Service Bulletin

American Honda Motor Co., Inc.

2001-2002 GL1800/A CB Radio Replacement

**GL1800/A #10
JANUARY 2002**

13P CB COUPLER

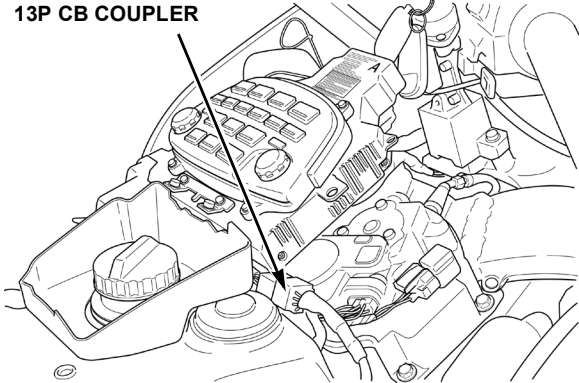
- Disconnect the antenna and 3P CB coupler from under the seat. **Carefully** reach under the right-hand side of the top shelter and disconnect the 13P CB coupler from in front of the fuel filler overflow tray.

CB TRANSCEIVER CABLE GROMMET

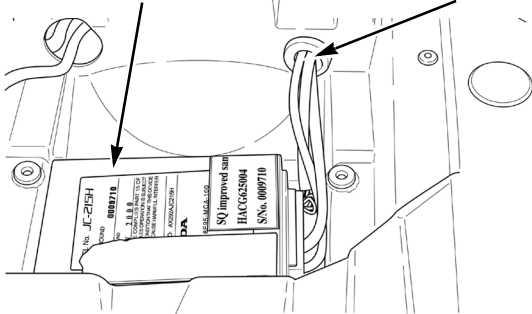
- Remove and replace the CB Transceiver. Reuse the cable grommet. Reinstall the foam cushions if they were removed. Reconnect the antenna and couplers. Save the shipping box from the replacement transceiver.

IDENTIFICATION

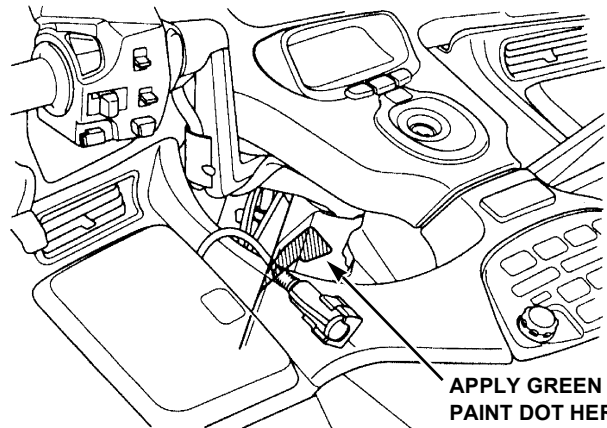
Put a green paint dot on the left hand frame spar to the right of the VIN plate.
